Permit # 2019-2662

Truss Repair Letter

Re: 490670
Lot 1446 WIV

January 10, 2020

Job	Truss	Truss Type	Qty	Ply	Lot 1446 WIV	Units: 1.0	I39837783
490670	M6	Roof Special	1	1		Eng: TH

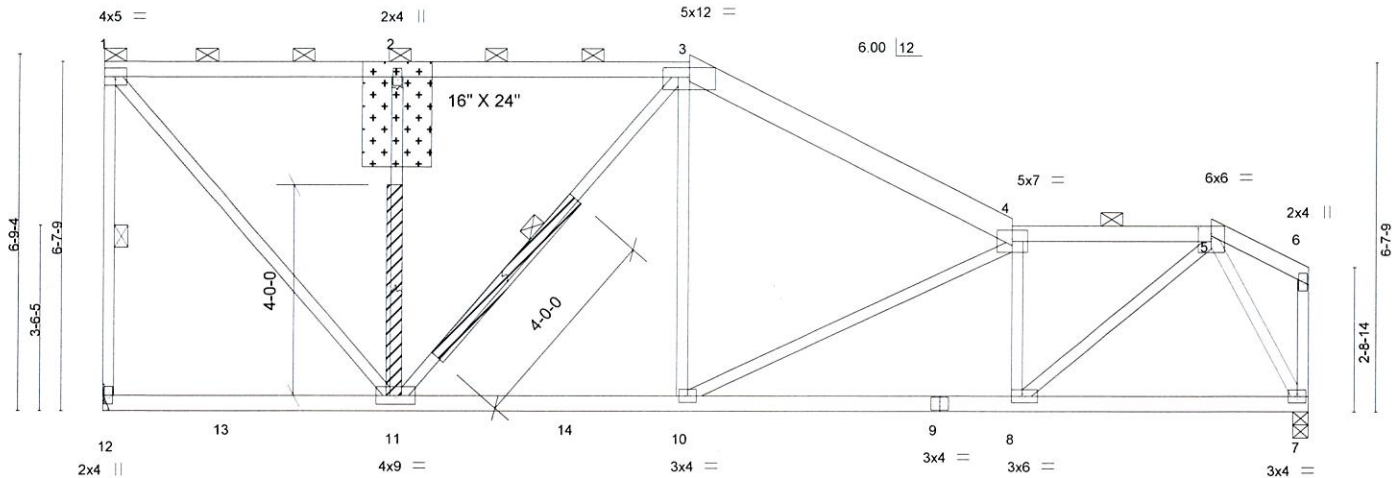
REPAIR: BREAK IN WEB 2-11 AT 24" FROM JOINT 11 AND JUST BELOW PLATE AT JOINT 2 AND BREAK IN WEB 3-11 AT 36" FROM JOINT 11.

ATTACH 7/16" OSB GUSSET (7/16" RATED SHEATHING 24/16 EXP 1) TO EACH FACE OF TRUSS WITH (0.131" X 2.5" MIN.) NAILS PER THE FOLLOWING NAIL SCHEDULE: 2 X 3'S - 2 ROWS, 2 X 4'S - 3 ROWS, 2 X 6'S AND LARGER - 4 ROWS: SPACED @ 4" O.C. NAILS TO BE DRIVEN FROM BOTH FACES. STAGGER SPACING FROM FRONT TO BACK FACE FOR A NET 2" O.C. SPACING IN EACH COVERED TRUSS MEMBER. USE 2" MEMBER END DISTANCE.

APPLY 2 X 4 X 4' SPF/DF/SP NO.2 SCAB(S) TO EACH FACE OF TRUSS CENTERED ON BREAK. ATTACH WITH (0.131" X 3") NAILS PER THE FOLLOWING NAIL SCHEDULE: 2 X 3'S - 1 ROW, 2 X 4'S - 2 ROWS, 2 X 6'S AND LARGER - 3 ROWS: SPACED @ 4" O.C. STAGGER NAIL SPACING FROM FRONT FACE AND BACK FACE FOR A NET 2" O.C. SPACING IN THE TRUSS. USE 2" MEMBER END DISTANCE.

Job	Truss	Truss Type	Qty	Ply	Lot 1446 WIV	Units: 1.0	I39837784
490670	M7	Half Hip	1	1		Eng: TH	
					Job Reference (optional)

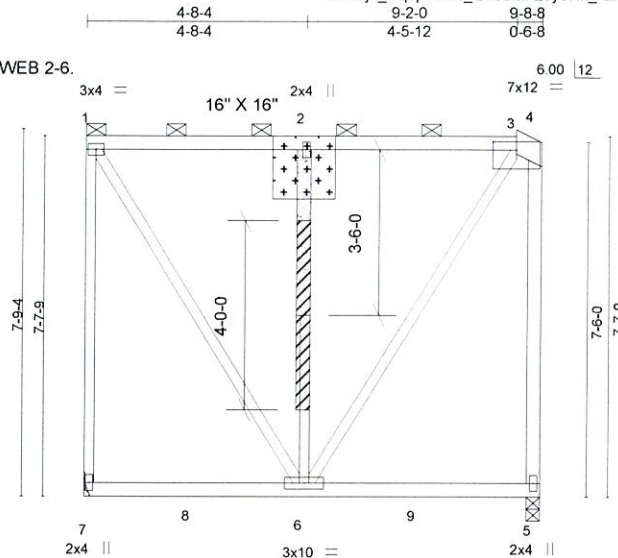
REPAIR: REPLACED SECTION OF WEB 2-6.

ATTACH 7/16\" OSB GUSSET (7/16\" RATED SHEATHING 24/16 EXP 1)
TO EACH FACE OF TRUSS WITH (0.131\" X 2.5\" MIN.) NAILS PER THE FOLLOWING NAIL SCHEDULE:
2 X 3'S - 2 ROWS, 2 X 4'S - 3 ROWS, 2 X 6'S AND LARGER - 4 ROWS: SPACED @ 4\" O.C.
NAILS TO BE DRIVEN FROM BOTH FACES. STAGGER SPACING FROM FRONT TO BACK FACE
FOR A NET 2\" O.C. SPACING IN EACH COVERED TRUSS MEMBER. USE 2\" MEMBER END DISTANCE.

INSTALL 2 X 4 SPF/DF/SP NO.2
CUT TO FIT TIGHT.

APPLY 2 X 4 X 4' SPF/DF/SP NO.2 SCAB(S) TO EACH FACE OF TRUSS CENTERED
ON BREAK. ATTACH WITH (0.131\" X 3\") NAILS PER THE FOLLOWING NAIL
SCHEDULE: 2 X 3'S - 1 ROW, 2 X 4'S - 2 ROWS, 2 X 6'S AND LARGER - 3 ROWS:
SPACED @ 4\" O.C. STAGGER NAIL SPACING FROM FRONT FACE AND BACK FACE
FOR A NET 2\" O.C. SPACING IN THE TRUSS. USE 2\" MEMBER END DISTANCE.
